RECEIVED
 OK'D BY: _____ OK'D BY: _____
 SEP 05 2006
 RESUBMIT: _____ APPROVED: *As Not'd*
 BY: *sl* DATE: 9/1/06

TRI-CHORD SIGN STRUCTURE
 I-89 SB EXIT 14W RAMP "C"
 CHITTENDEN COUNTY, VERMONT
 CITY OF SOUTH BURLINGTON
 PROJECT No. ACIM 089-3(37)

DATE: 8/29/06
 SCALE: N.T.S.
 SHEET NO.: 1557
 REVISION: 0
 SHEET NO.: 3 of 10

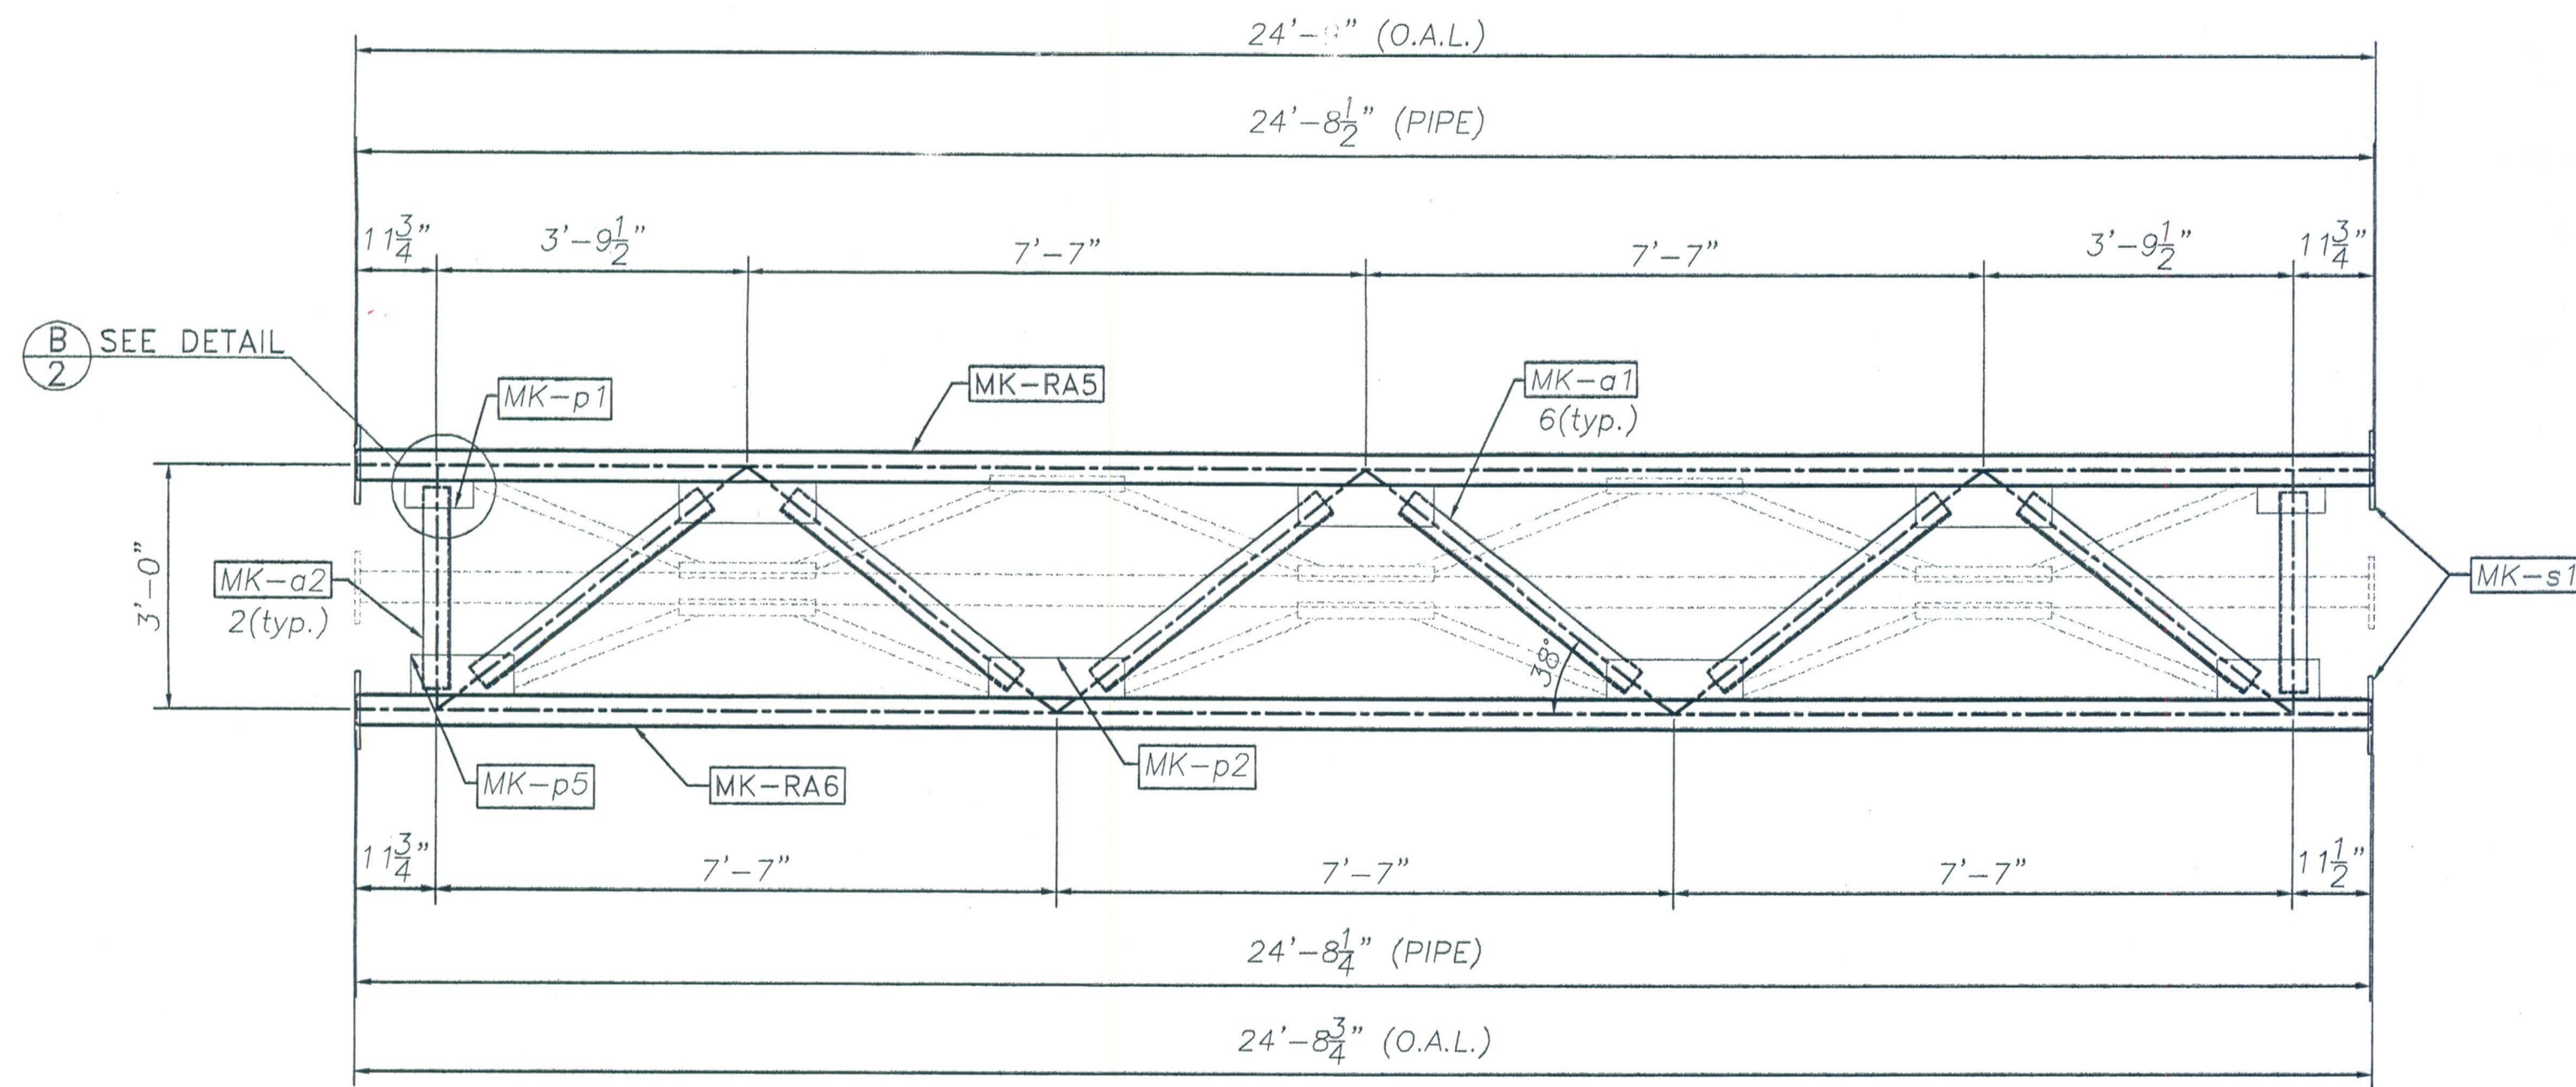
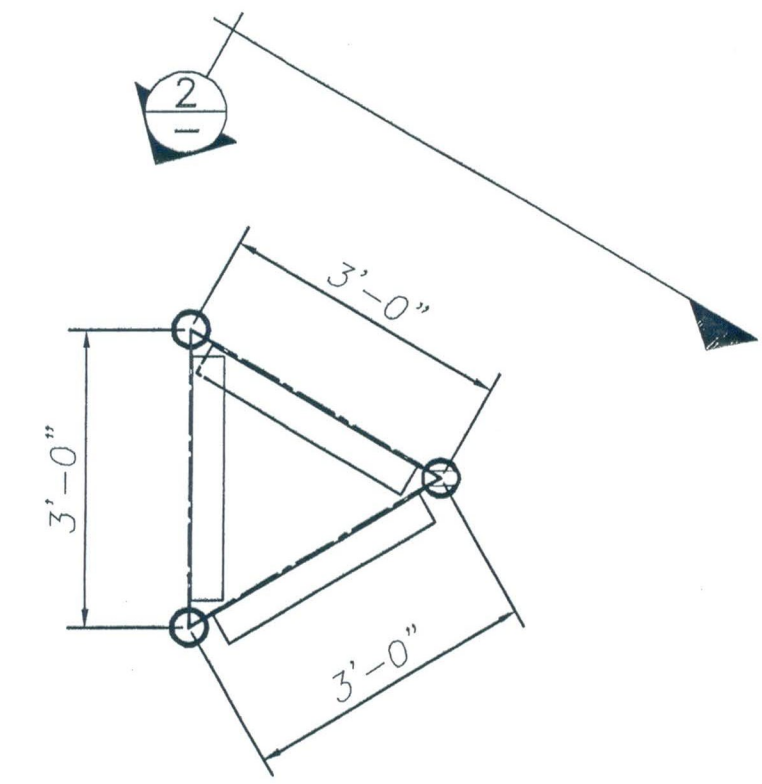
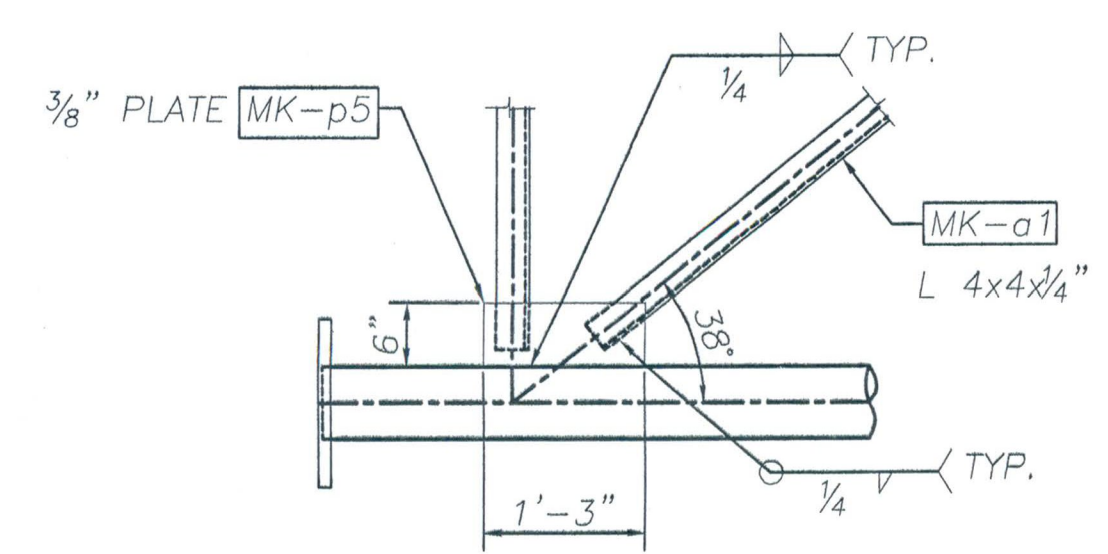
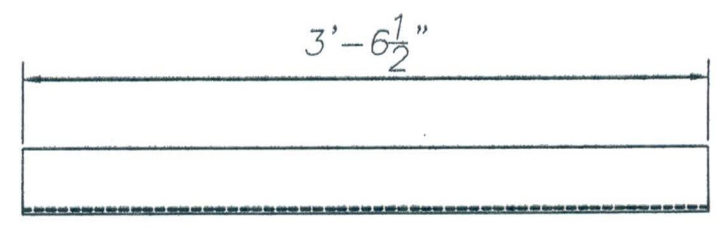
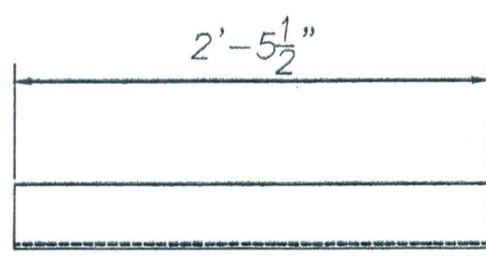
- STEEL PIPES FOR STRUCTURAL MEMBERS SHALL HAVE MINIMUM YIELD OF 42 ksi AND SHALL CONFORM TO ONE OF THE FOLLOWING GRADES: ASTM A500 GR. B, ~~OR API 5L X~~.
